PLANT NAME: Duane Arnold Plant

IOWA ELECTRIC LIGHT AND POWER COMPANY

IE-77-551

PROPOSED CHANGE RTS-82 TO DAEC TECHNICAL SPECIFICATIONS

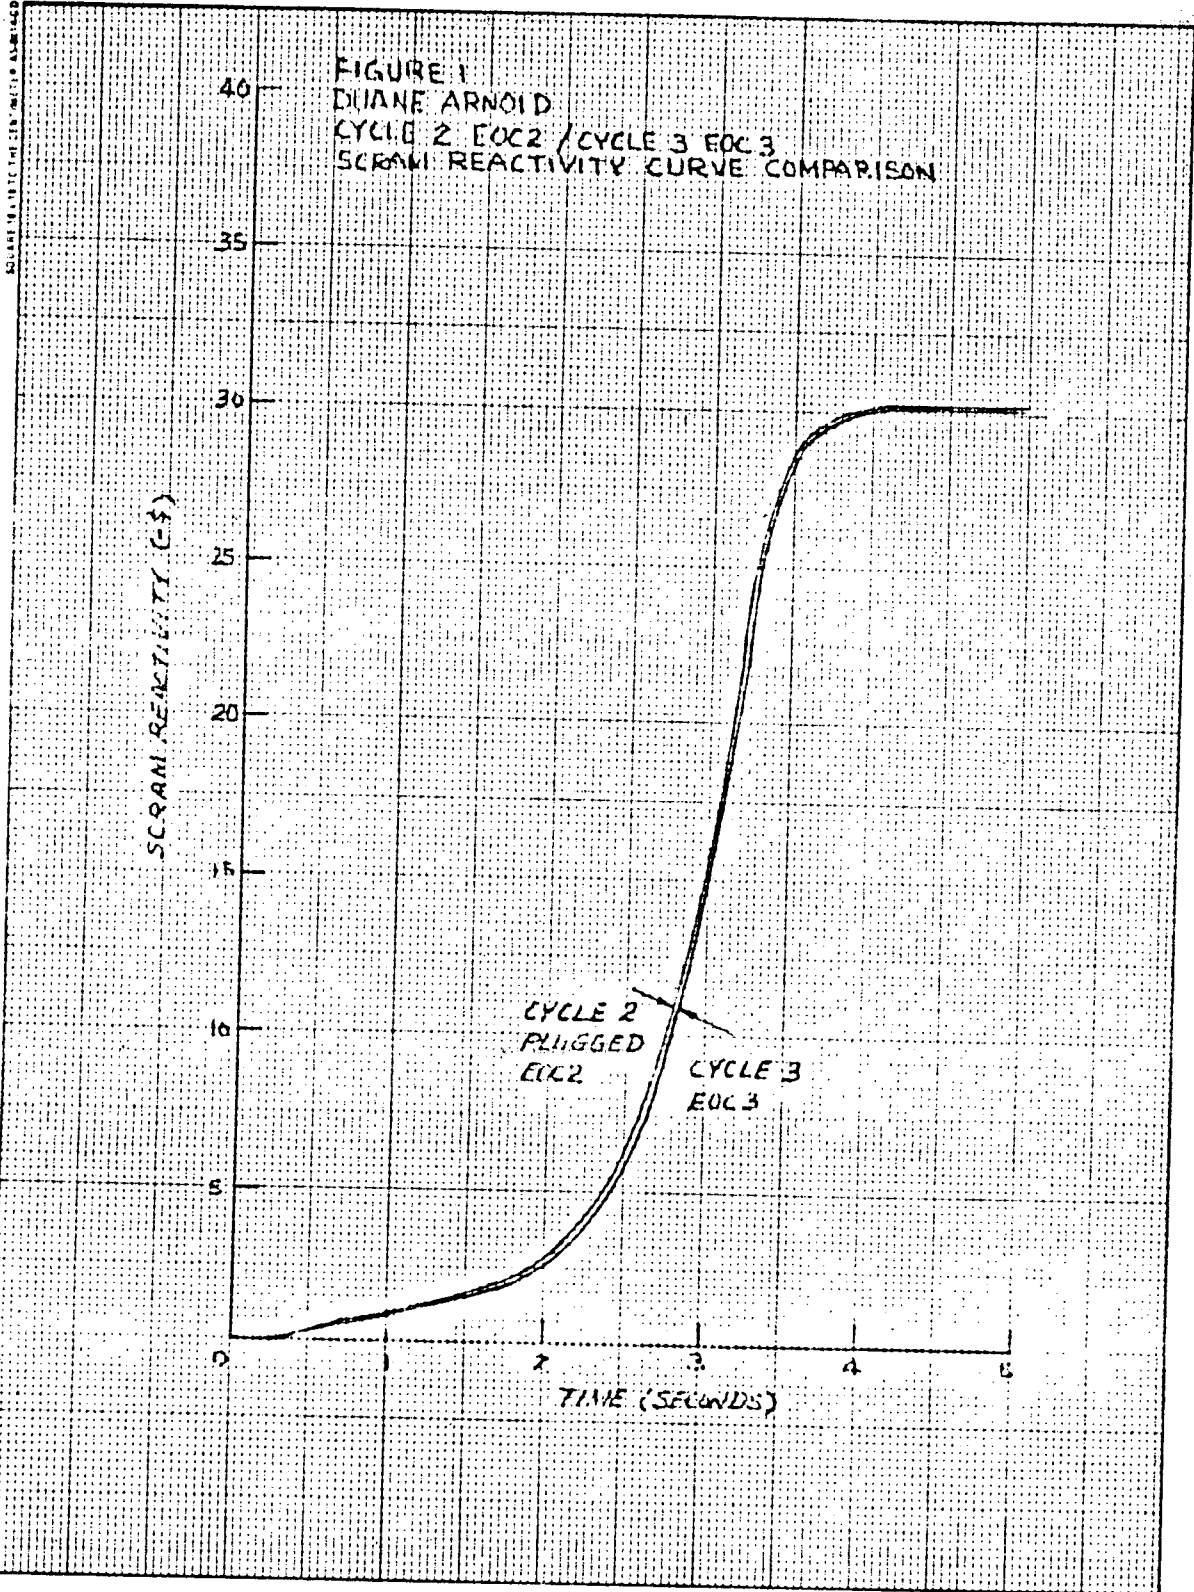
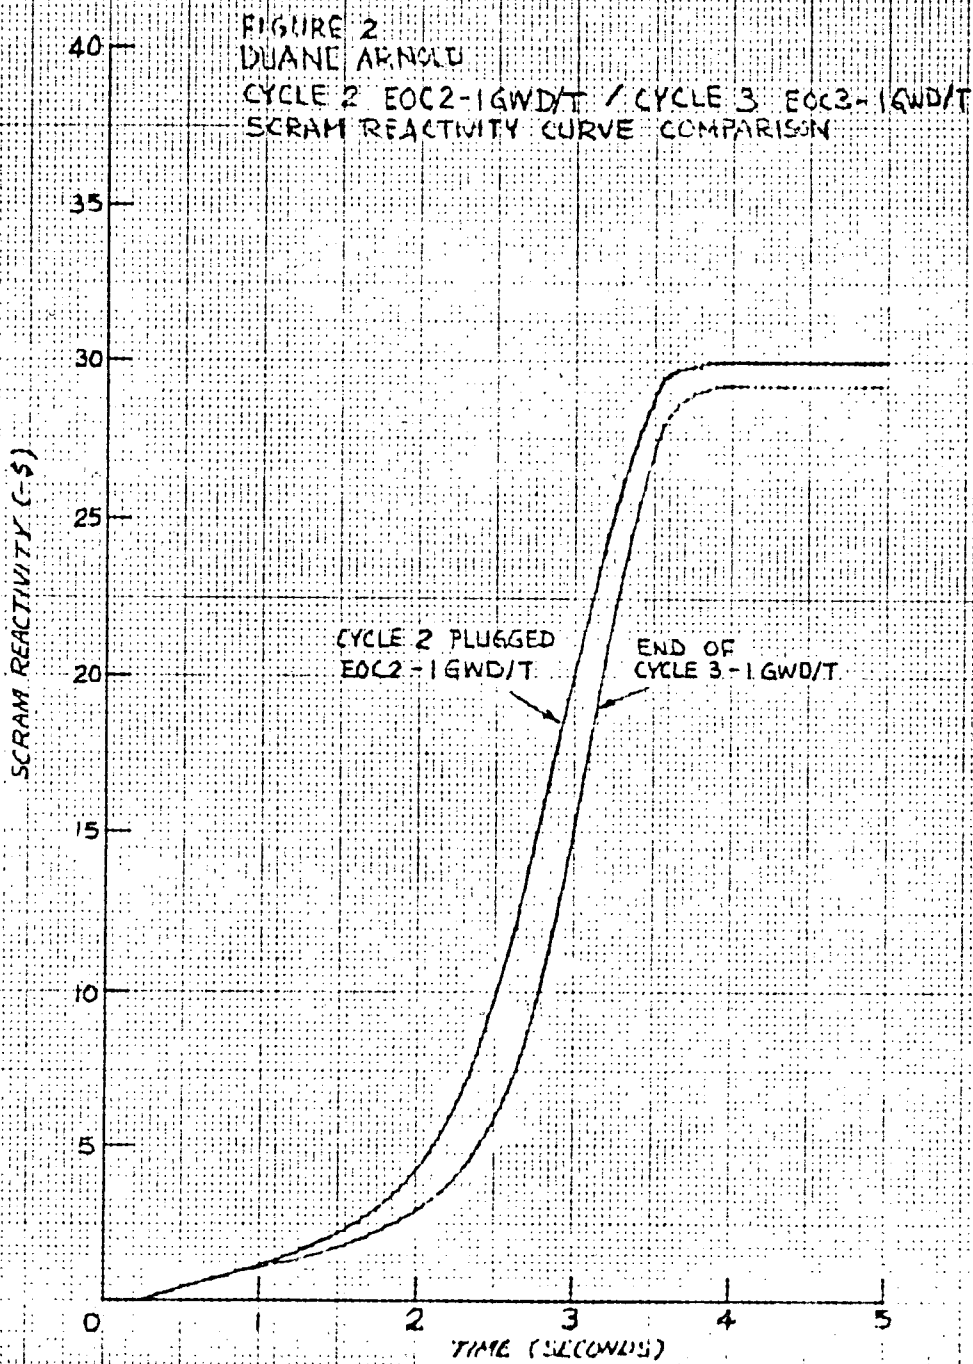
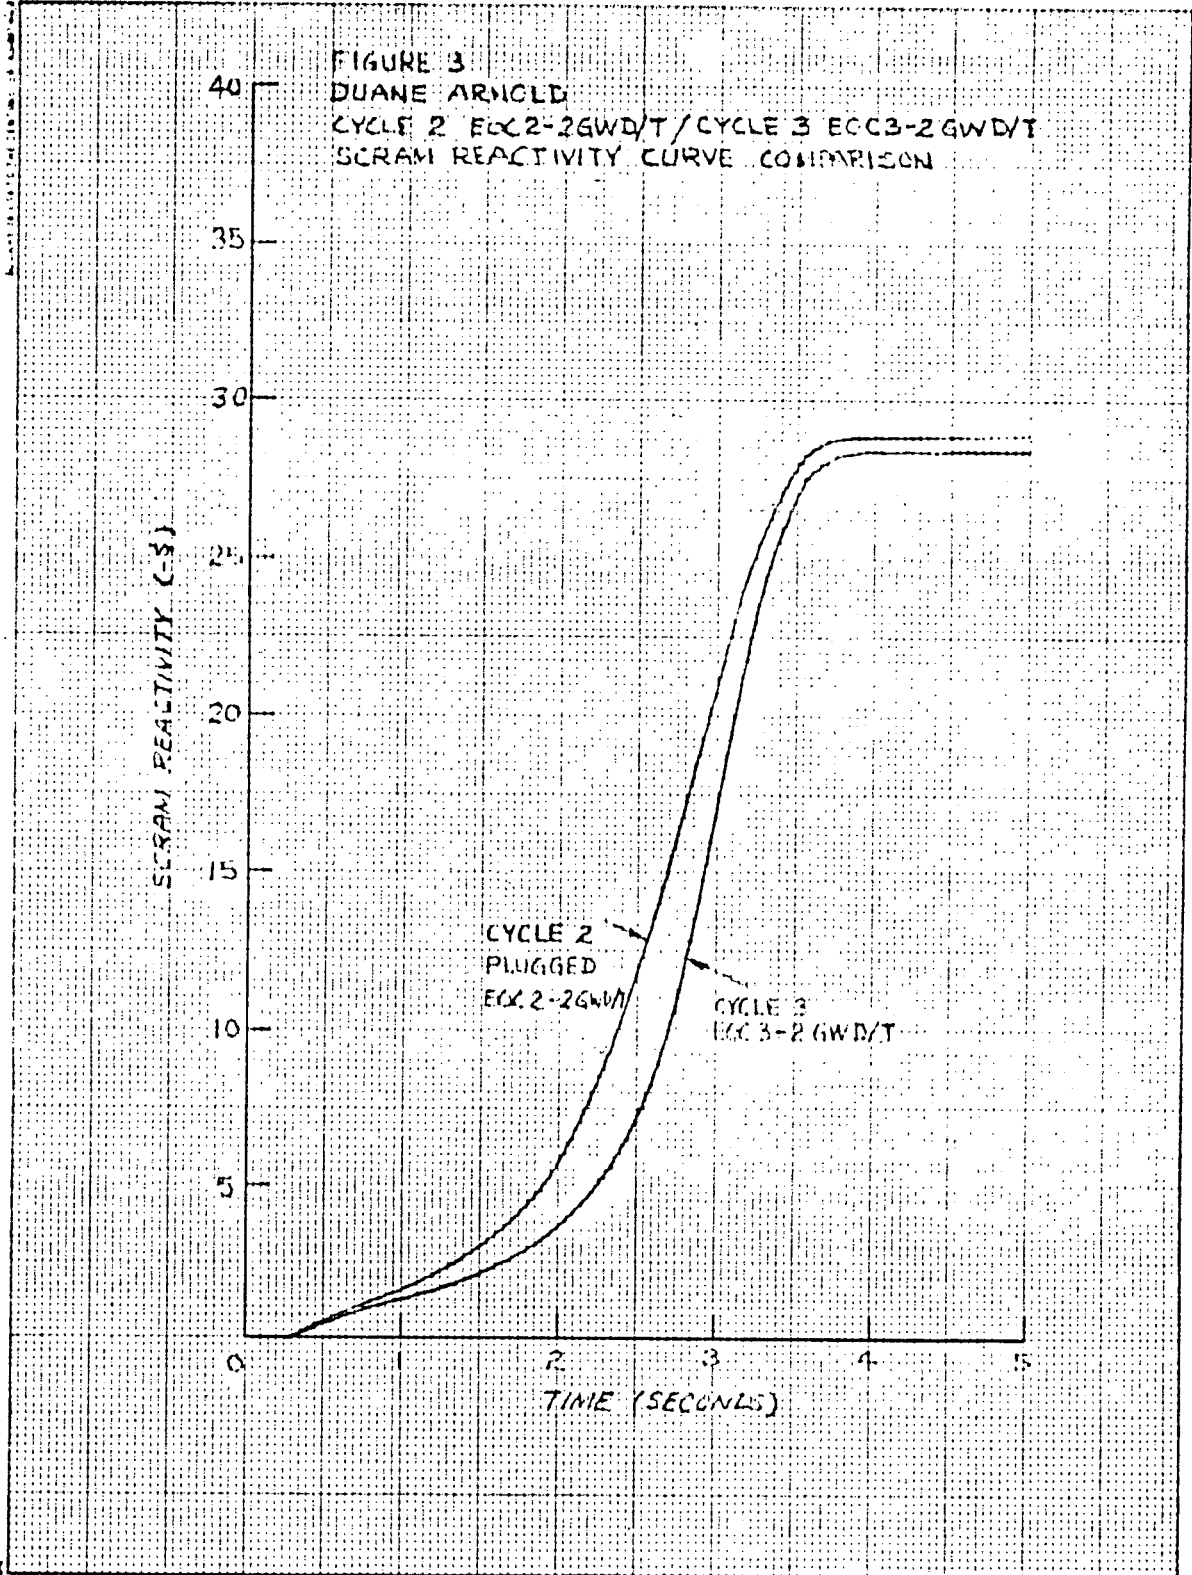
Provide a quantitative discussion of the Δ CPR's given in Table 6-3 NEDO 21082-2.

Cycle 2 and Cycle 3 void coefficients and Δ CPR's are as follows:

<u>V.C.</u>	<u>ΔCPR</u>	
		<u>8x8</u>	<u>7x7</u>
EOC2	-14.36 ¢/%	0.37	0.28
EOC2-1GWD/T	-16.93 ¢/%	0.27	0.19
EOC2-2GWD/T	-16.88 ¢/%	0.23	0.17

<u>V.C.</u>	<u>ΔCPR</u>	
		<u>8x8</u>	<u>7x7</u>
EOC3	-13.27 ¢/%	0.37	0.27
EOC3-1GWD/T	-14.47 ¢/%	0.36	0.28
EOC3-2GWD/T	-14.40 ¢/%	0.29	0.21

Smaller void coefficients in Cycle 3 are expected to result in Δ CPR's that are lower than Cycle 2 which has higher void coefficients. However, scram reactivity degradation experienced in Cycle 3 more than compensated for the benefit of improvement in the void coefficients. Figure 1, 2, 3 show the degradation in the scram reactivity between Cycle 2 and Cycle 3 exposure points

analyzed. Note that Figures 1, 2, 3 are based on the same data submitted in the licensing submittals, minor variations may exist due to variations in replotting and scaling.
